Technical Bulletin / Safety Alert

Unique ID No: DES2009-TBSA-03

Rev: 2

Subject: Inlet Flametrap Alteration to MDR090376DES & MDA DES 13017

Inlet Flametrap Gap Check Procedure:

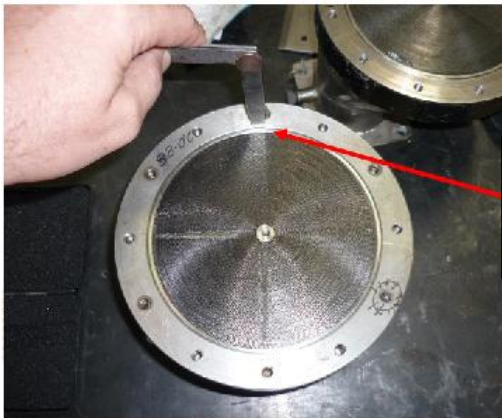
As a result of the abovementioned expiries, the Inlet Flametrap flamepath gap for all diesel engine systems covered under design registration MDR090376DES and approval MDA DES 13017 (for plant manufactured prior to 1 January 2007) must conform to the requirements of AS3584.2:2008, Clause 2.6.3 Open Joints, which is a maximum gap of 0.2mm.

Feeler Gauge Test: Check and record maximum gap between the Flametrap Housing and Flametrap Element. The maximum allowable gap is 0.2mm at any one point.

Feeler gauge inserted into gap as shown.
Measurements to be made at multiple positions
around Housing-Element circumference.

Specified Gap = 0.2mm Maximum

Any Gap in excess of 0.2mm constitutes an out of specification assembly.

Inlet Flametrap Gap Check Procedure

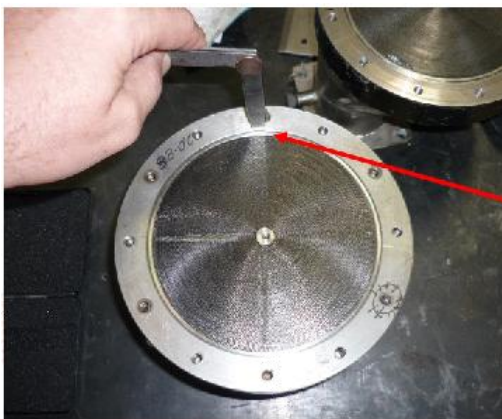
Feeler Gauge Test: Check and record maximum gap between the Flametrap Housing and Flametrap Element. The maximum allowable gap is 0.4mm at any one point.

Feeler gauge inserted into gap as shown. Measurements to be made at multiple positions around Housing-Element circumference.

Specified Gap
0.4mm Maximum

Any Gap in excess of 0.4mm constitutes an out of spec. assembly.
